AGENDA ITEM EXECUTIVE SUMMARY			Agenda Item number: 4f	
	Title:	Plan Commission recommendation to approve a PUD Preliminary Plan for First Street Redevelopment PUD Lot 6.			
CITY OF ST. CHARLES ULINOIS+ 1834	Presenter:	Ellen Johr	ison, Planner		
Meeting: Plan	Meeting: Planning & Development Committee Date: April 8, 2024				
Proposed Cost: \$ E			Budgeted Amount: \$	Not Budgeted:	
TIF District: None					
Executive Summary (if not budgeted, please explain):

Staff Report Plan Commission Meeting – April 2, 2024

Applicant:	City of St. Charles	First Street PUD – Lot 6
Property Owner:	City of St. Charles	Illinois St.
Location:	West side of S. 1 <sup>st</sup> Street b/w Illinois and Indiana Streets	
Purpose:	City parking lot & 1 <sup>st</sup> Street Streetscape	
Application:	PUD Preliminary Plan	2 nd St
Public Hearing:	Not required	
Zoning:	CBD-1 Central Business District / PUD	Indiana St.
Current Land Use:	Public parking	
Comprehensive Plan:	Mixed Use	Subject Property
Summary of Proposal:	submitted for reconst the former Blue Goos year, the City entered building to reconstruct lot will provide addition portion of the lot will Proposed plans for th asphalt/stripping, lan lot frontage of

LANDSCAPE LEGEND

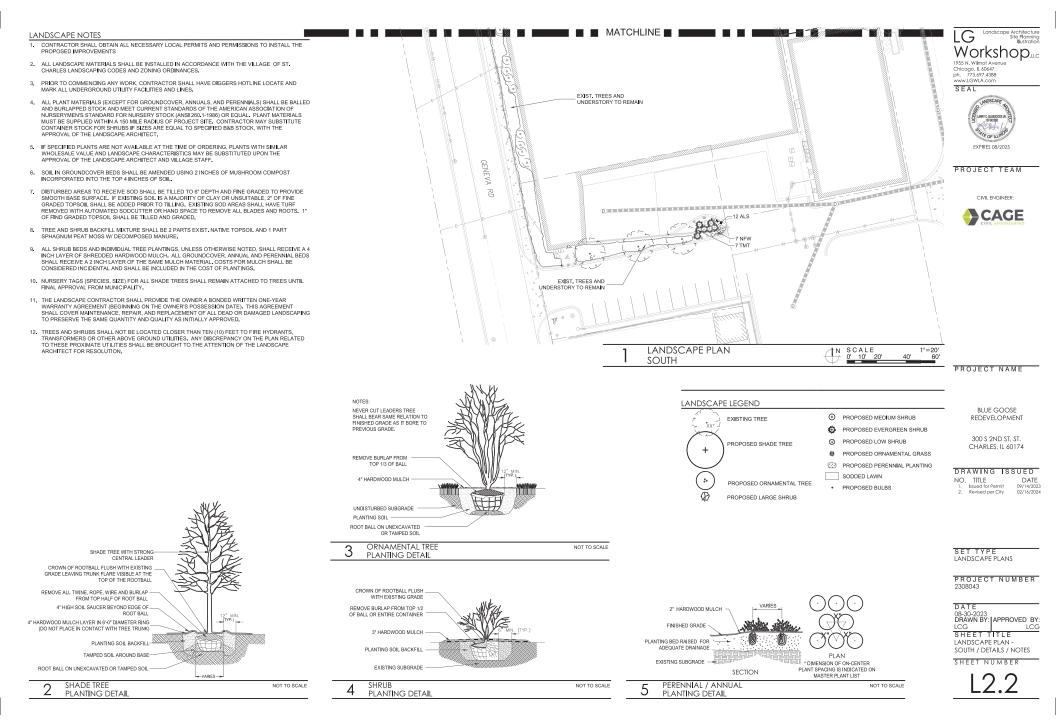
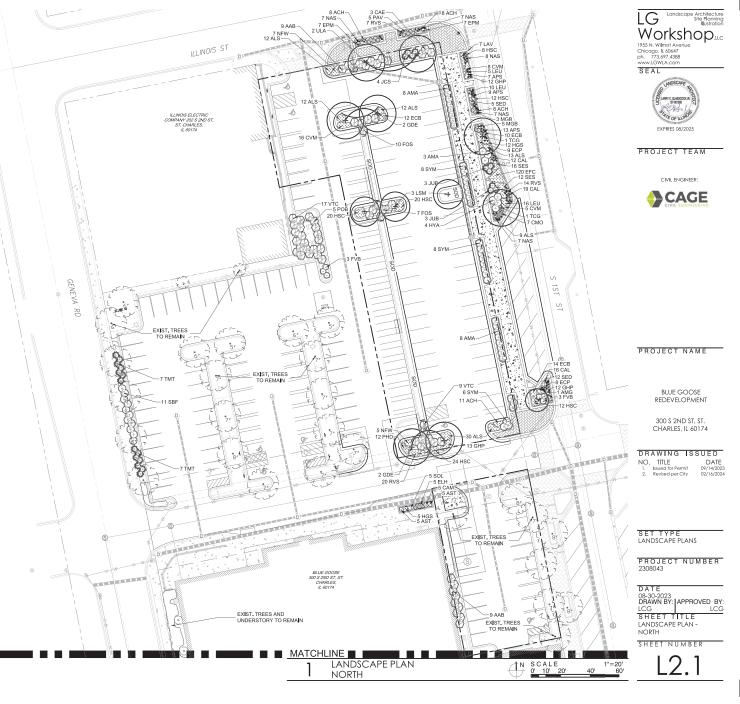
- Remove the narrow strip of turf grass strip that runs between parking rows as this will be difficult to maintain.
- Replace the Linden trees on 1<sup>st</sup> St with a different species that has a more standard canopy appearance.
- Remove the tree at the corner of 1<sup>st</sup>/Indiana due to visibility concerns.
- Add pavement markings or a speed bump to delineate public vs. private parking.

- ✓ Plantings are needed adjacent to the parking stall at the northwest corner of the parking lot.
- ✓ The middle island on the east side of the parking lot is planted with only sod; a variety of plantings are needed.

- ✓ One of the parking lot light poles is located over the double parking lot island. This will be in conflict with the trees and plantings within the island. The pole will need to be relocated.
- ✓ The site layout shall be updated to reflect the current site plan.

- ✓ One accessible parking stall is needed on 1<sup>st</sup> Street. This will decrease the number of onstreet stalls to 8.
- ✓ The on-street parking stalls shall be concrete.

- ✓ Bike parking has been requested. Suggested locations are at the north and south ends of the parking lot, within the sidewalk where there is a break in the parking lot planter beds.

- ✓ Irrigation of the planting areas will be required.
- ✓ Use of additional brick pavers along 1<sup>st</sup> Street is desired. However, staff is assessing the availability of matching brick pavers to accomplish this.

- ✓ An electrical site plan for the streetscape lighting is needed, identifying power source, conduit routing and fixture details. The southernmost pedestrian light fixture should be shifted to be in line with the other pedestrian fixtures.

- ✓ Street/pedestrian light fixtures matching the decorative street lights used along 1<sup>st</sup> Street will be required.
- ✓ The Electric Utility has recommended not using any overhead roadway lighting as it is not needed. The existing mid-block light on First St. shall be replaced with a pedestrian fixture.
